PCB 07-01325 ISSUE 3

CHANGE REQUEST

SCALE 2:1		DATE 26-6-90		TITLE 8580 FILTER & DEMOD ASSEMBLY	
DRN	MJS	CHKD	RRS	APPD	CM
TOLERANCES UNLESS OTHERWISE STATED				DRAWING/DOC. NO. 08-03937	
2 PLACES DEC. ±				ISS	
1 PLACE DEC. ±				1	
ANGULAR ±				SHT 1 OF 1

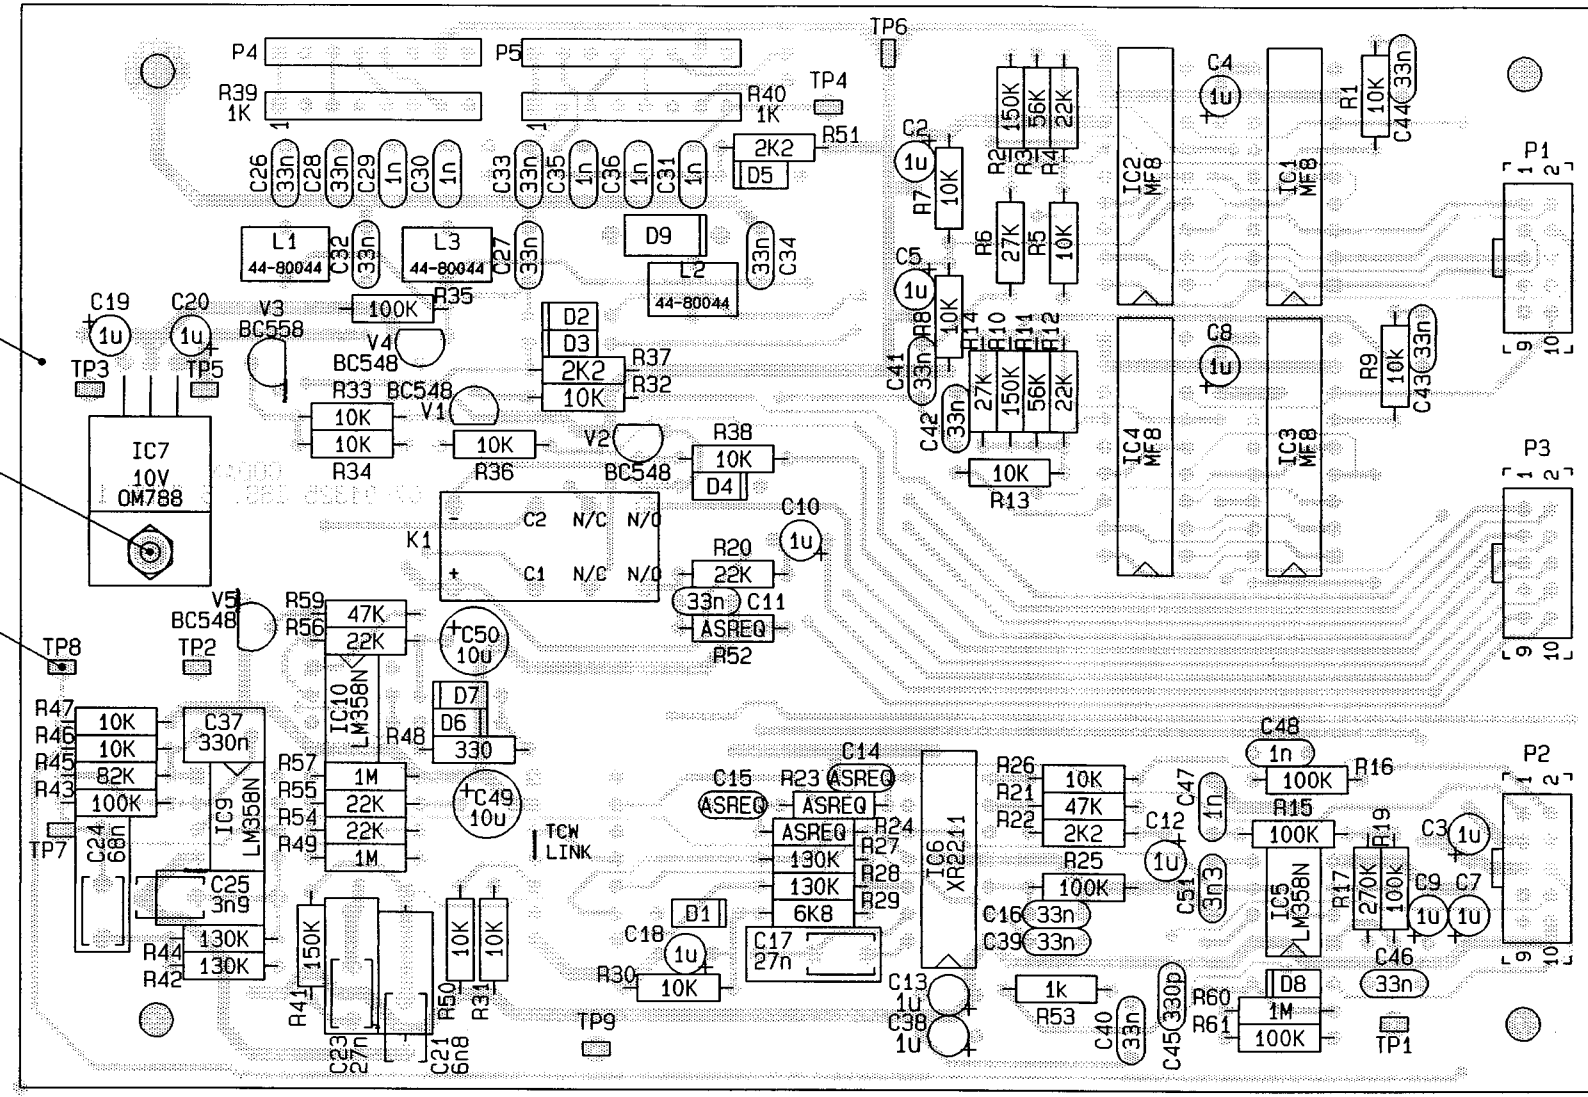
ISSUE B
C/R 22451, 22509
ADD D9, LK1 &
LK2 TO PCB.
SFD 28-06-91

ISSUE C
C/R 22999
C13 WAS SHOWN
AS C15 ON SILK
SCREEN. MTG PAD
ENLARGED. PCB
WAS ISSUE 2.
CE 07-11-91

ISSUE D
IC8 DELETED.
LINK ADDED.
C/R 23150
SFD 17-12-91

ISSUE E
R29 WAS 5K6
R45 WAS 220K.
C/R 23250
SFD 22-06-92
